May 31, 2016

Re: FirstLight Hydro Generating Company, Turners Falls Hydroelectric Project (FERC No. 1889) and Northfield Mountain Pumped Storage Project (FERC No. 2485).
Response to Stakeholder Requests for Study Modifications and/or New Studies Based on the Study Report and Meeting Summary

Attachment A to Study 3.6.5
Revised Figure 4.4-1. Licensee Owned Lands

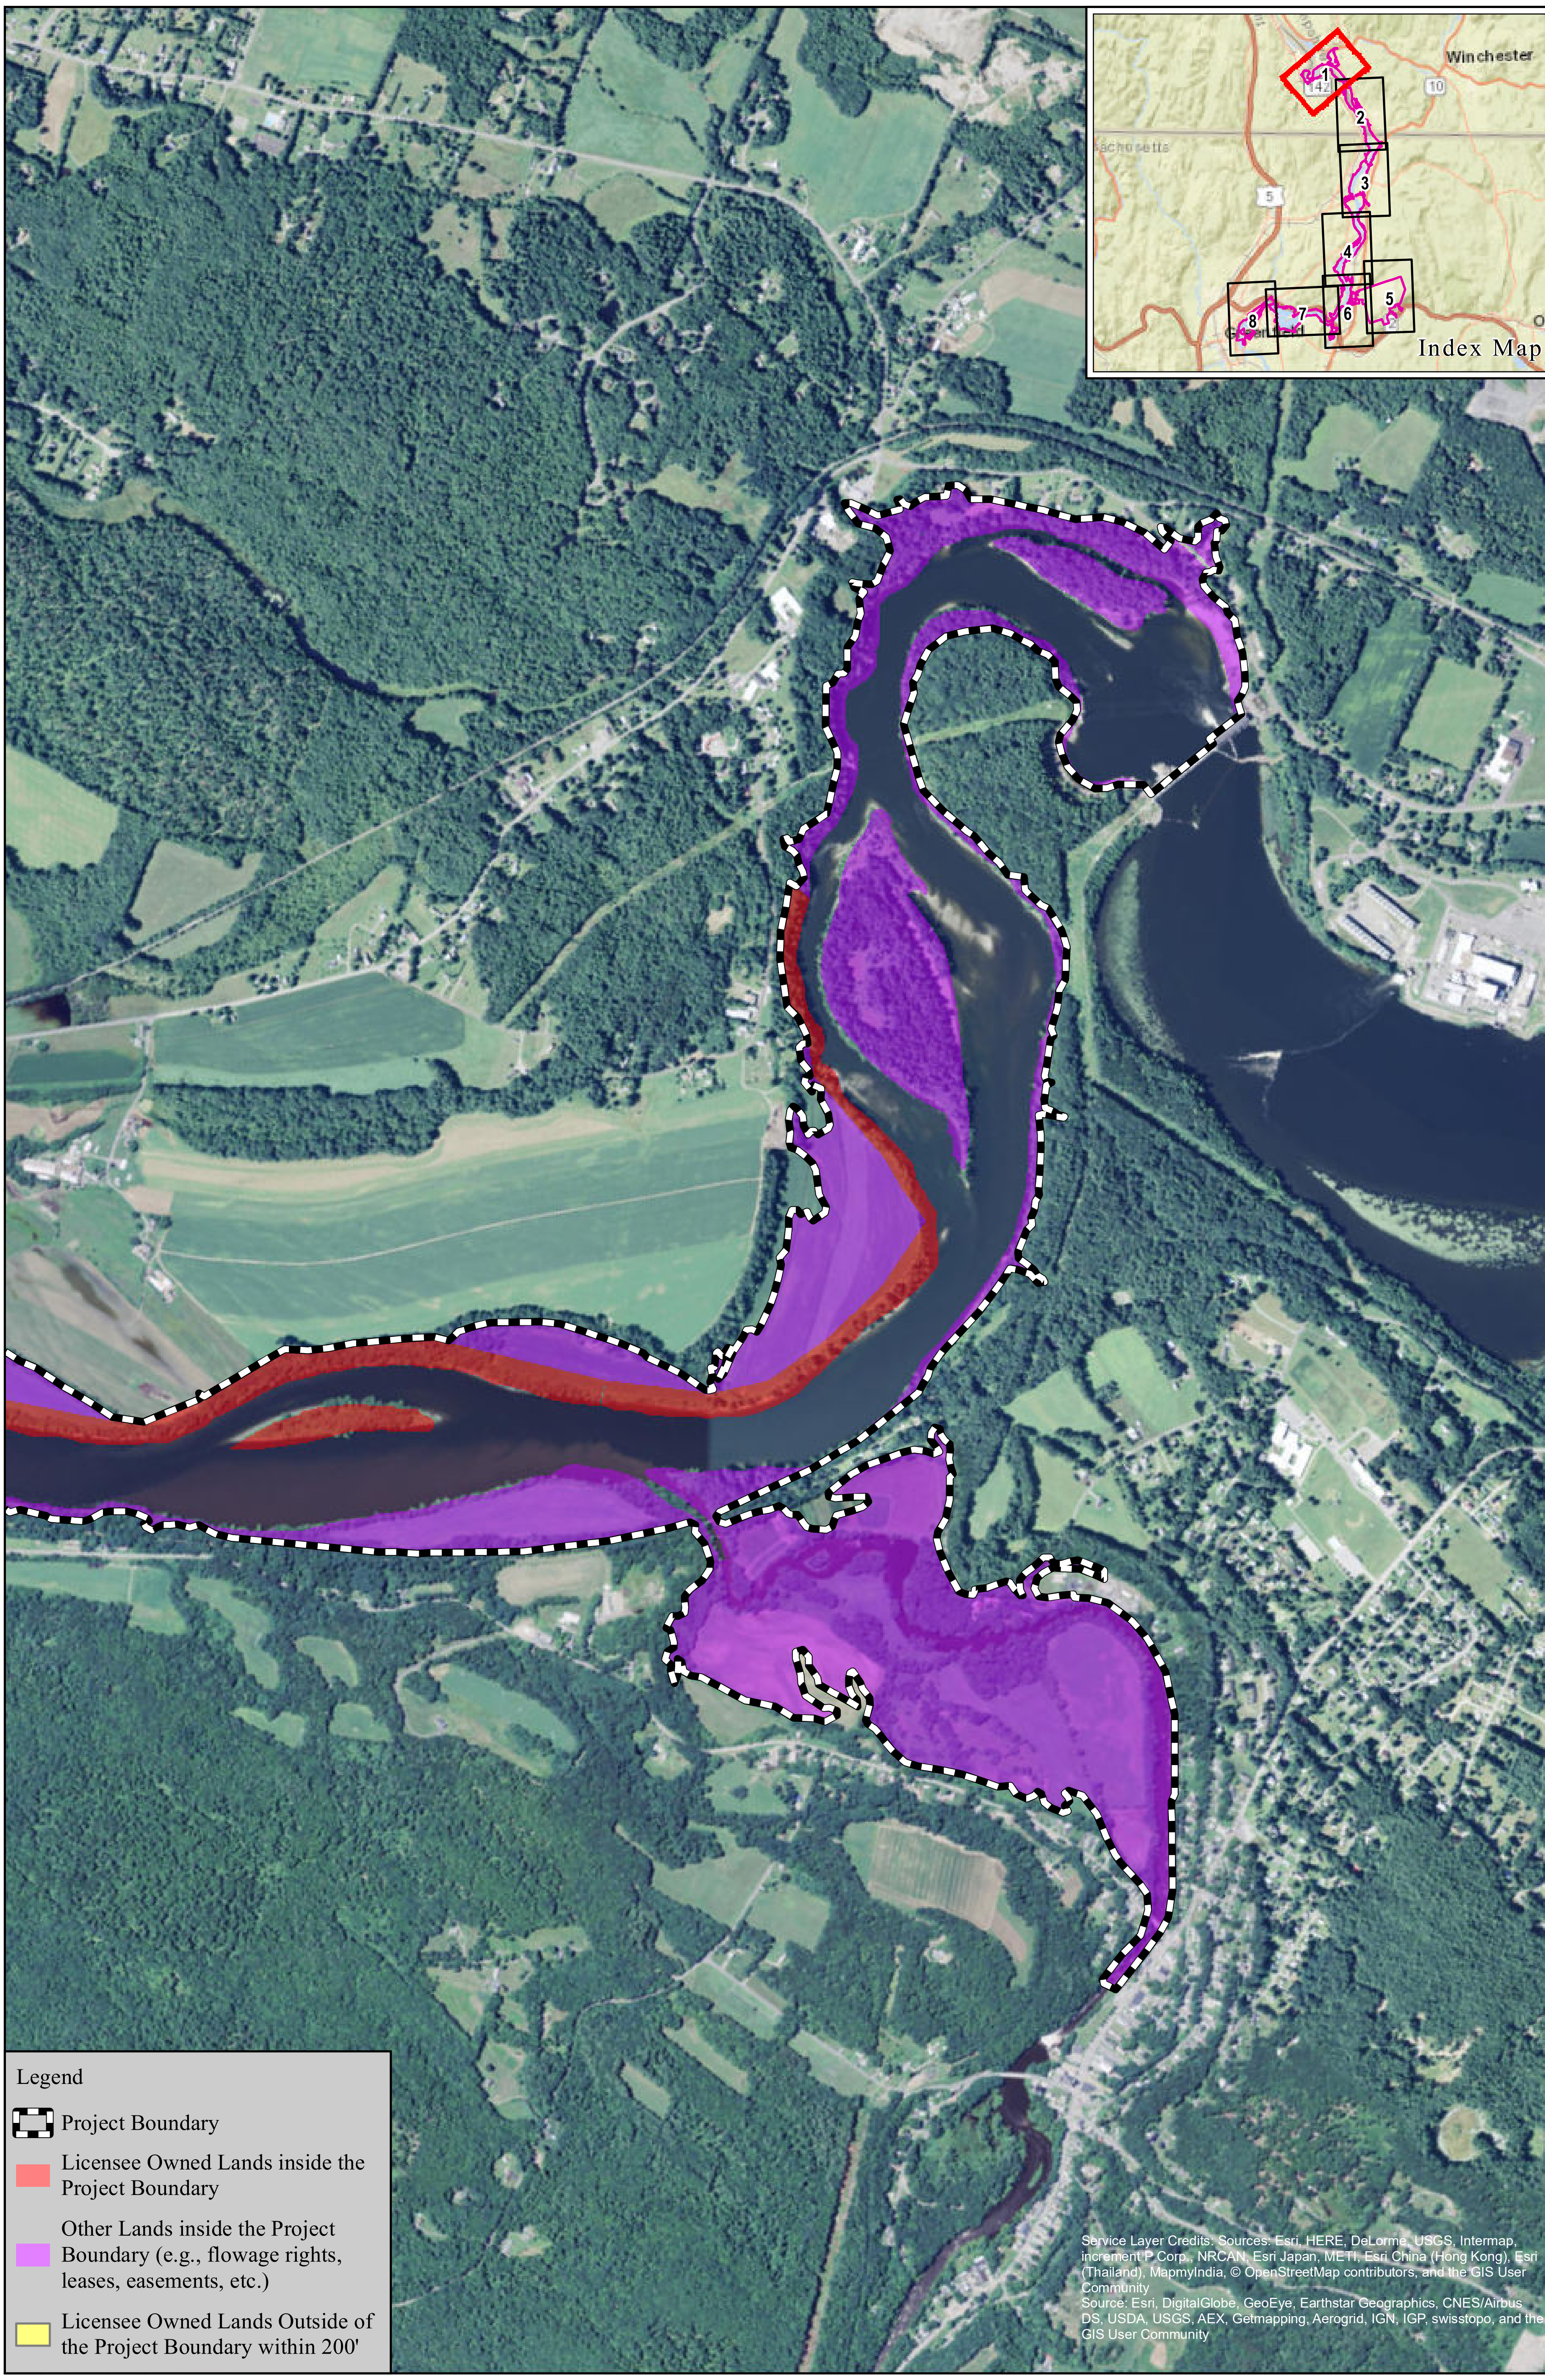
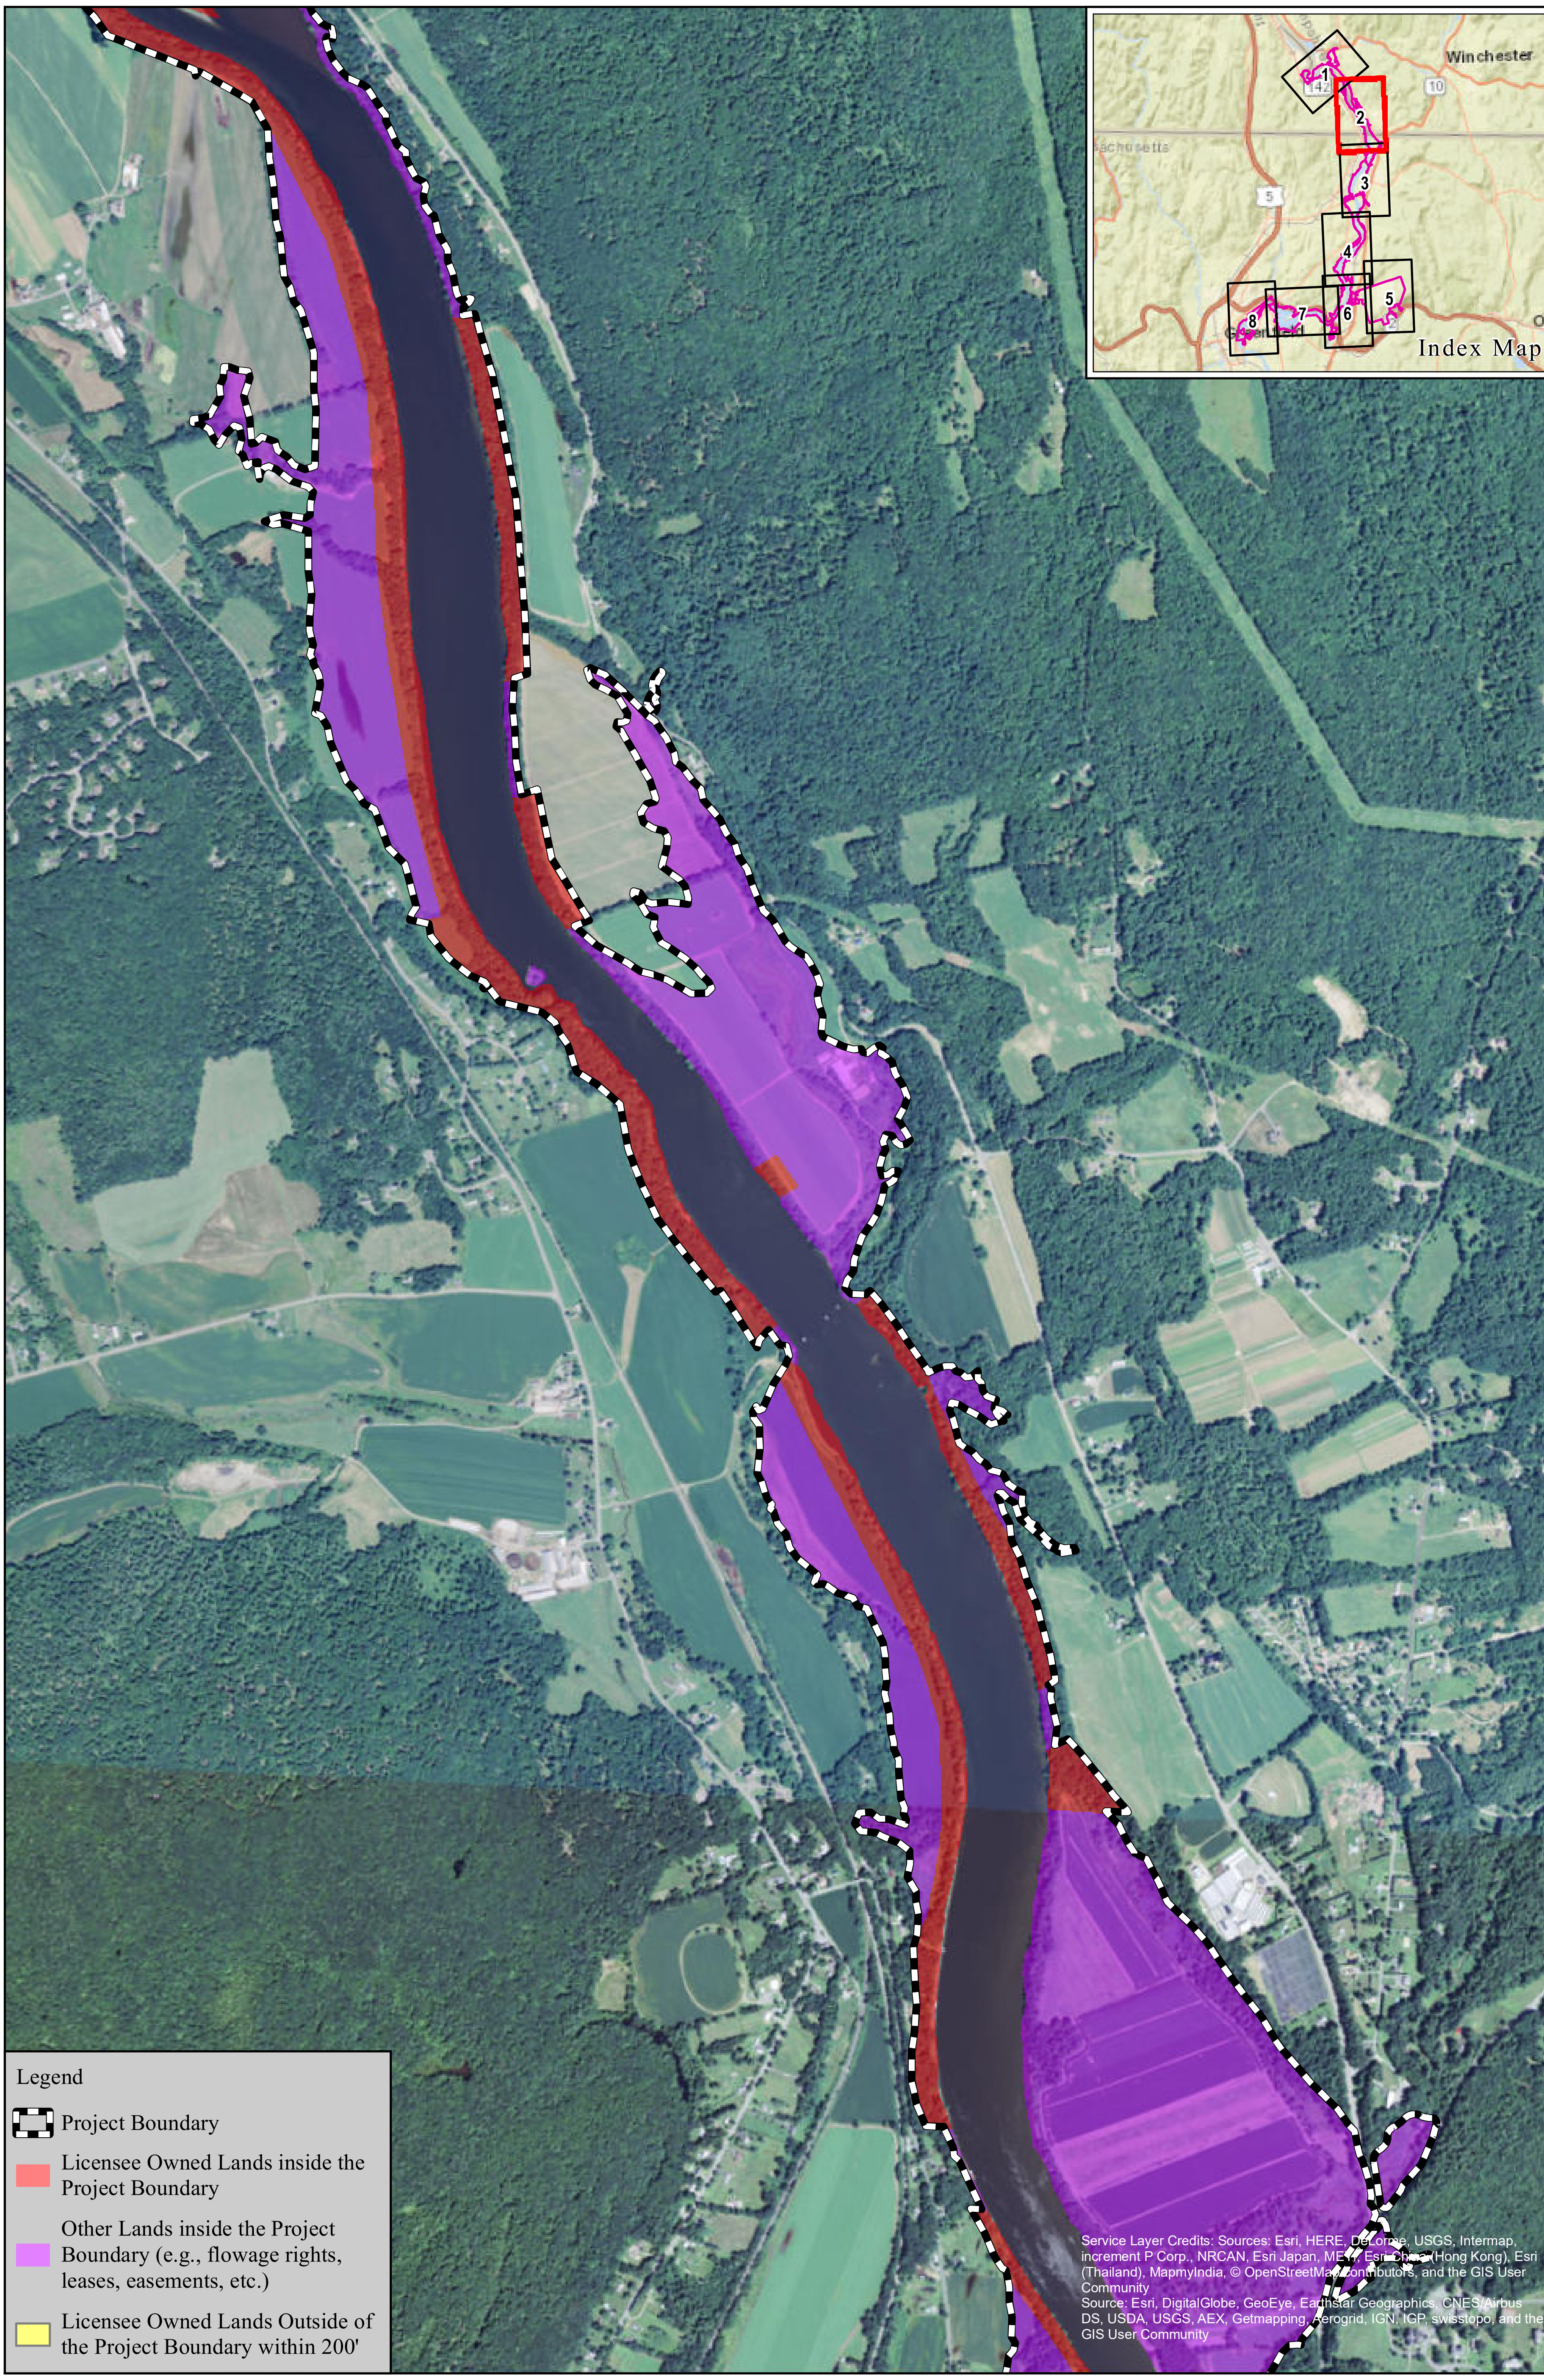
Commenter	Comment	Responses
CRWC-1	The report does not identify ownership and other controls such as FirstLight's flowage rights within the Project boundaries. FirstLight does not own all of the lands within the project boundaries. FirstLight ownership of lands within 200 feet of the Project boundaries is identified in Figure 4.4-1, but nothing indicates ownership within the boundaries. CRWC requests that FirstLight provide information on land it has ownership or any other control over, and the land use associated with those lands, in an addendum to Study 3.6.5.	FL has updated the maps that comprise Figure 4.4-1 in the 3.6.5 study report to show FL land ownership within the project boundary. See Study 3.6.5 Attachment A, Figure 4.4-1. The lands owned by FL shown are fee-ownership. The figures also show other lands within the Project boundary (e.g., flowage rights, easements, leases, etc.). The land uses associated with all lands within the Project boundary are provided in the 3.6.5 study report. An addendum to the 3.6.5 study report is not necessary.
